Access Compliance Report

Public Rights-of-Way

(Curb Ramps)

Intersection ID: 20044	Main Street: CARIBOU_CT	Cross Street: FALLOW_LN	Location:	N
ADA ID: 774960230CCE	Ramp Type: BlendTrans2	Initial Pass/Fail: Fail	Overall Compliance: No	Severity Score: 25
Codes/Mitigation Info/Possible Solution		Field Measurements/Component Compliance

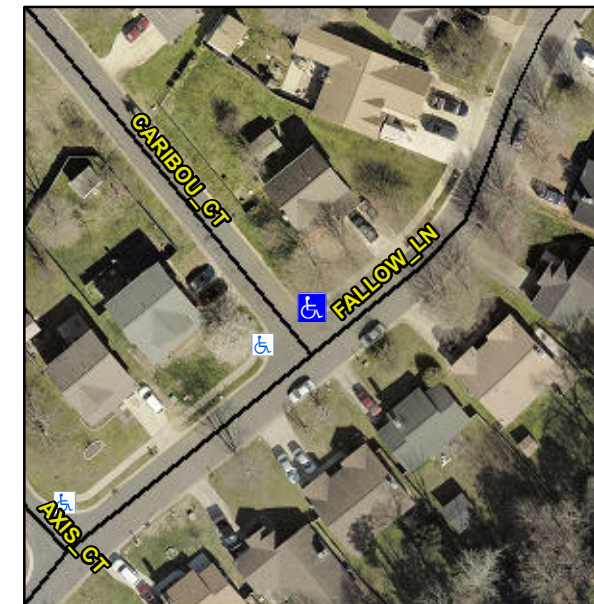
Not Found, R304.5.3

Compliance	Description	Data	Compliance	Description	Data
N/A	Ramp Length (in)	99.0	Yes	BlendTrans Slope (%)	3.3
Yes	Ramp Width (in)	56.0	No	BlendTrans XSlope (%)	7.7
N/A	Flare Type LT	N/A	N/A	Flare Type RT	N/A
N/A	Flare Slope LT (%)	N/A	N/A	Flare Slope RT (%)	N/A
N/A	Flare Traversable LT?	N/A	N/A	Flare Traversable RT?	N/A
N/A	Landing Length (in)	N/A	N/A	DWS Provided?	N/A
N/A	Landing Width (in)	N/A	N/A	DWS Contrast?	N/A
N/A	Landing Slope (%)	N/A	N/A	DWS Length (in)	N/A
N/A	Landing X Slope (%)	N/A	N/A	DWS Full Width?	N/A
N/A	Landing Curb? (Y/N)	N/A	N/A	DWS Offset (in)	N/A
N/A	Shared Landing?	N/A			
N/A	Gutter Ponding?	N/A	N/A	Gutter Slope (%)	N/A
N/A	Gutter Lip Ht (in)	0.5	N/A	Gutter X Slope (%)	N/A
N/A	Painted X Walk1?	No	N/A	Painted X Walk2?	No
	X Walk 1 Direction	To SW		X Walk 2 Direction	To SE
	X Walk 1 Width (in)	N/A		X Walk 2 Width (in)	N/A
	X Walk 1 Slope (%)	3.3		X Walk 2 Slope (%)	4.3
	X Walk 1 X Slope (%)	4.0		X Walk 2 X Slope (%)	4.8

N/A	Ramp inside XWalk1?	N/A	N/A	Ramp inside XWalk2?	N/A
	Road Slope (%)	4.5		Clear Space?	N/A
	Road X Slope (%)	4.2	N/A	Clear Space to XWalk (in)	N/A
N/A	Any Obstructions?	N/A	N/A	Storm Grate/Utility Hazard?	N/A
	Obstruction Type			Storm Grate/Utility Type	
		N/A			N/A
			Yes	Surface Condition? (G/P)	Good
			No	Curb Slope (%)	7.3

Remove & Replace Curb Ramp With Two New Directional Ramps or Equivalent.
